UNITED STATES
NUCLEAR REGULATORY COMMISSION
WASHINGTON, D.C. 20555-0001

SUBJECT: QUAD CITIES NUCLEAR POWER STATION, UNITS 1 AND 2- STAFF
ASSESSMENT OF RESPONSE TO 10 CFR 50.54(f) INFORMATION REQUEST
- FLOOD-CAUSING MECHANISM REEVALUATION (CAC NOS. MF1108 AND
MF1109)

STAFF ASSESSMENT BY THE OFFICE OF NUCLEAR REACTOR REGULATION
RELATED TO FLOODING HAZARD REEVALUATION REPORT
NEAR-TERM TASK FORCE RECOMMENDATION 2.1
QUAD CITIES NUCLEAR POWER STATION, UNITS 1 AND 2
DOCKET NOS. 50-254 AND 50-265

Figure 3.2-1. Probable Maximum Precipitation Distribution at Quad Cities Nuclear Power Station (1-h 1-mi²) (Exelon, 2015a)

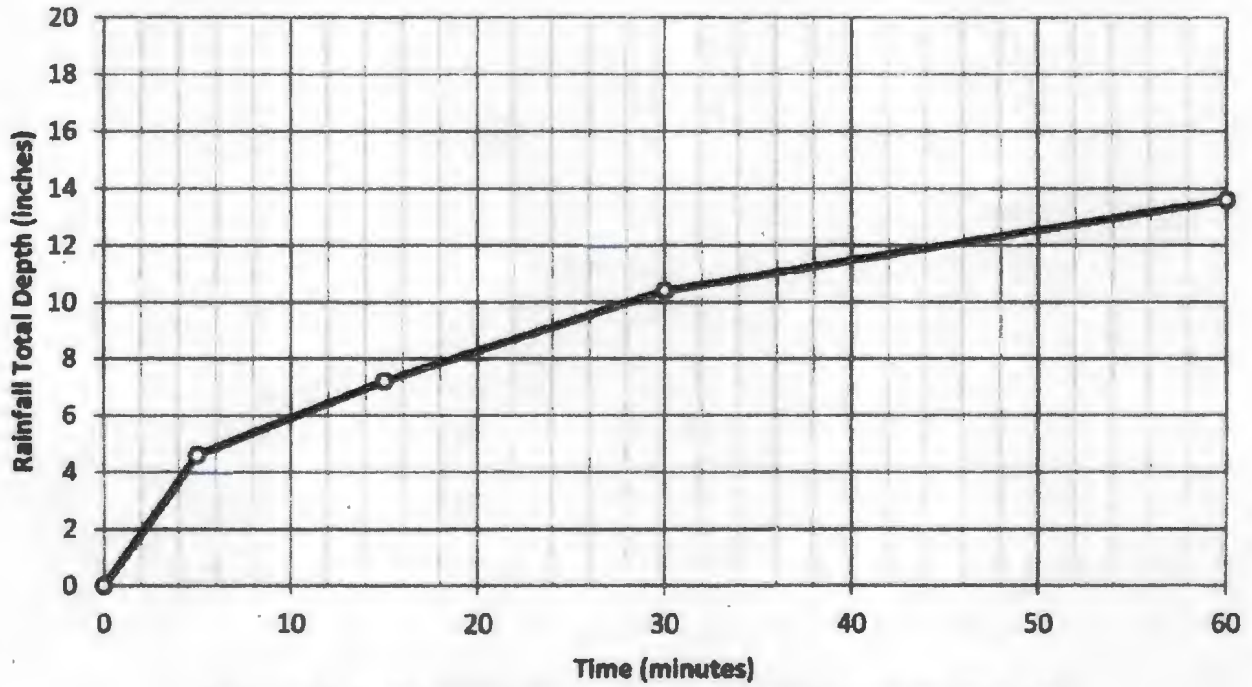
The NRC staff performed a separate sensitivity analysis on the temporal distribution of the rainfall (ORNL, 2015). The sub-hourly PMP depths for the 5-minute (min), 15-min, and 30-min time intervals were calculated by the licensee using ratios obtained from Figures 36, 37, and 38 of HMR 52 (Exelon, 2015a; NOAA, 1982). The rainfall hyetograph was arranged by the licensee using a front-loaded distribution, with the highest rainfall intensity occurring at the event onset (Exelon, 2015a). The licensee stated that the type of storm indicative of an LIP event would likely be a mesoscale convective system, which is associated with a zone of convergence and very intense initial precipitation that would maintain "a decrease in the precipitation after the initial burst as the rear trailing stratiform region with the cold pool moves over the area," thus fitting with a front loaded distribution (Exelon, 2014b). While this statement is true for some historical LIP-scale storms, alternative rainfall distributions have also frequently occurred. The

NRC staff's sensitivity analysis changed the rainfall distribution in the hydraulic model (FLO-2D) to a center weighted temporal distribution, as shown in Figure 3.2-1, and then computed the maximum water surface elevation at various locations around the site (ORNL, 2015). As expected, the results of this sensitivity study did increase the water depths around the site. However, the increases in water depths were small, with differences of 1.1 to 3.4 in. (2.7 to 8.6 cm) of the licensee's results (ORNL, 2015). Therefore, the NRC staff concluded that the licensee's temporal distribution of the ssPMP values is reasonable input to the hydraulic model and site drainage analysis discussed below.
